# Memo

Date: June 2, 2010  
File: OCP08-0016; TA08-0004; Z08-0044  
To: City Manager  
From: City Clerk  
Subject: CD 21 - Main Issues for Council

## CD21 Challenges:

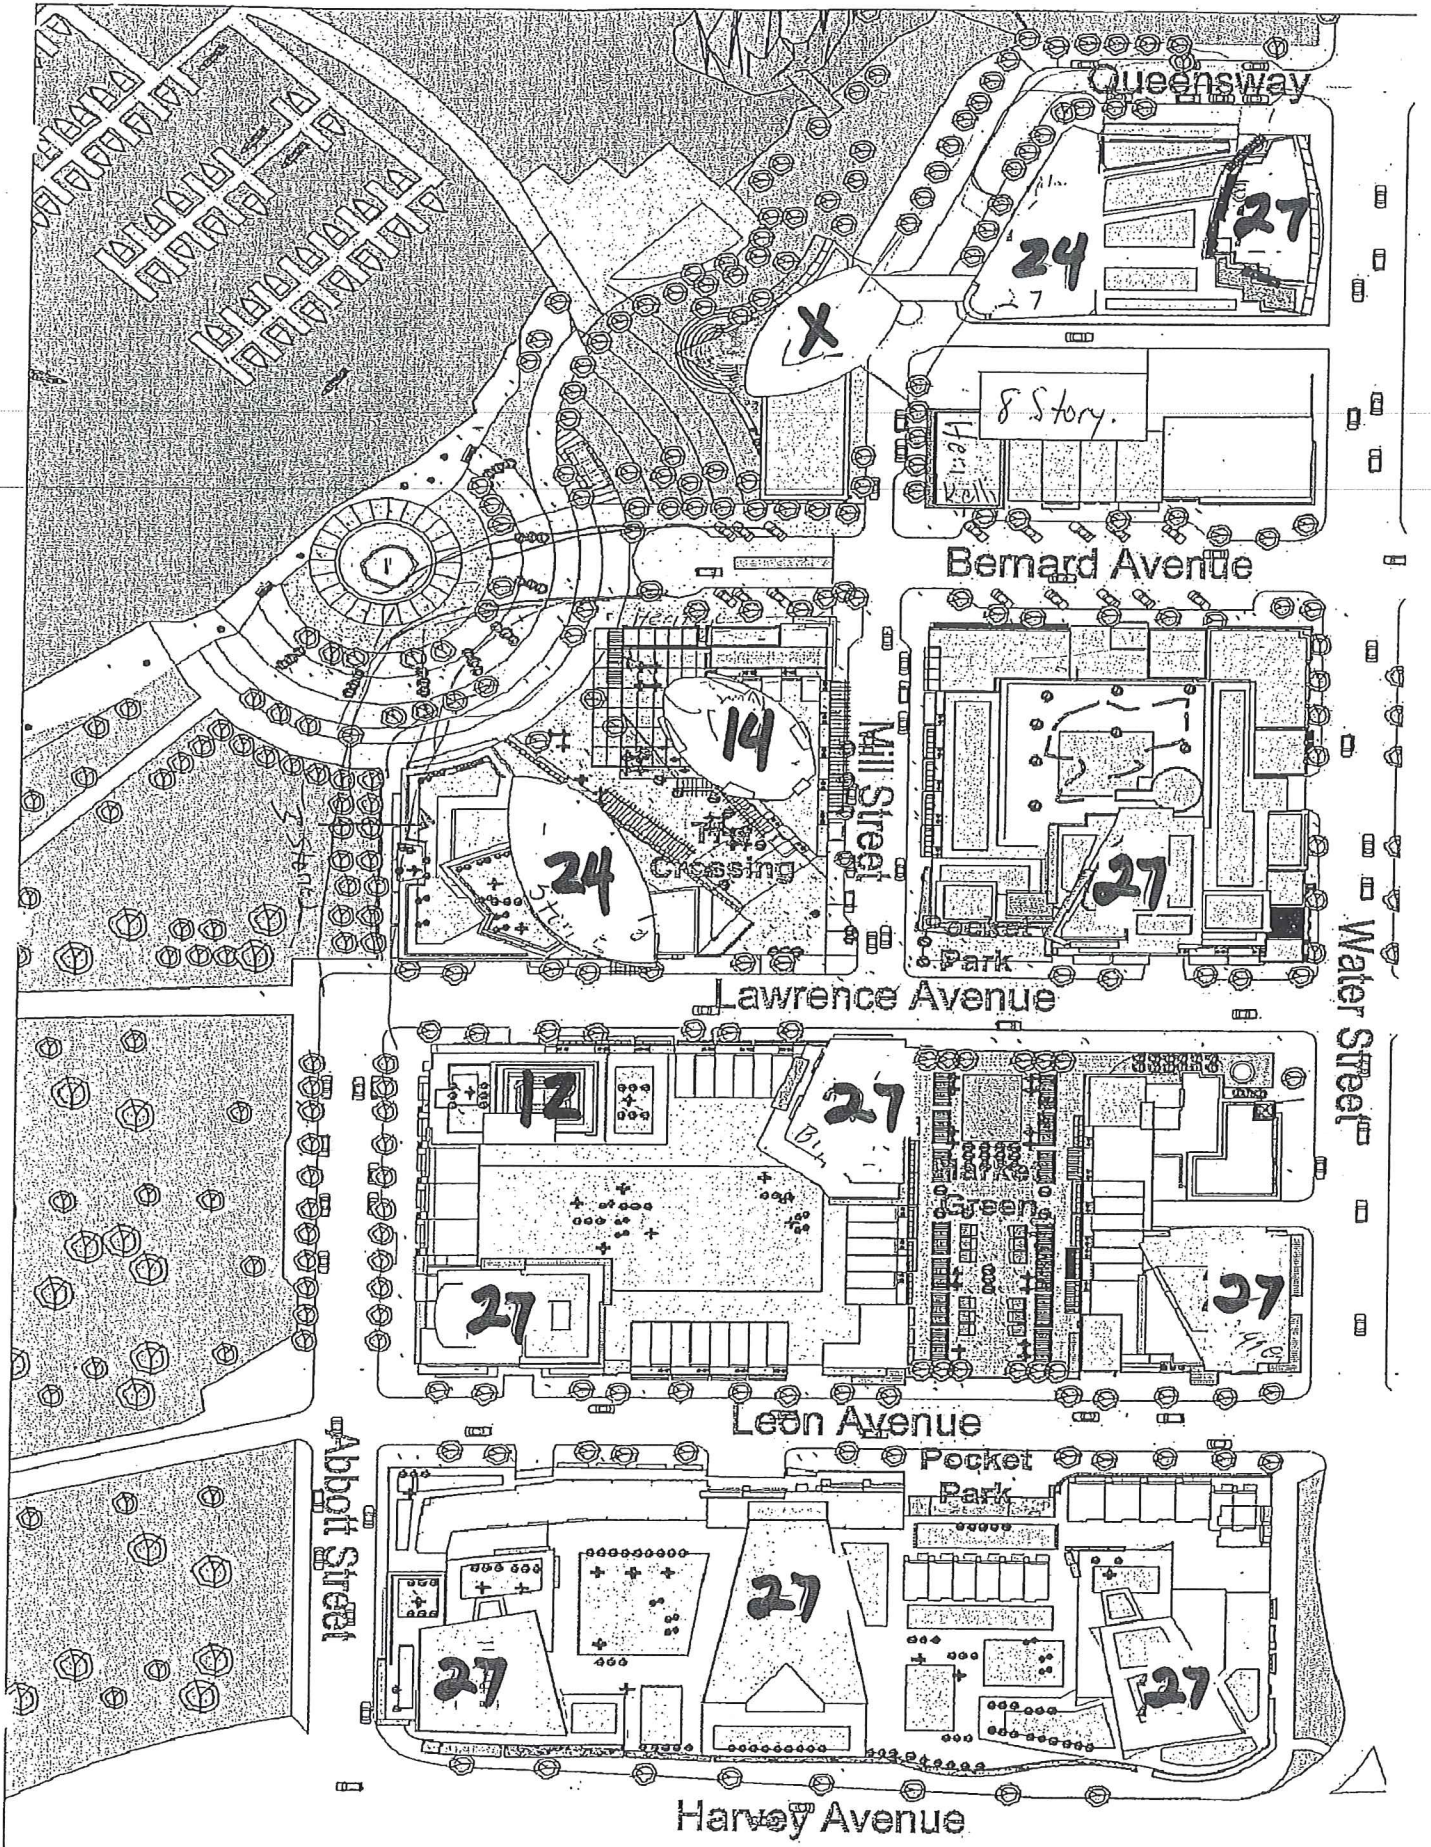
**PLEASE NOTE:** In addition to the above, each member of Council is to identify what heights and building locations in the present CD21 Zone are acceptable. (See attached Drawing)
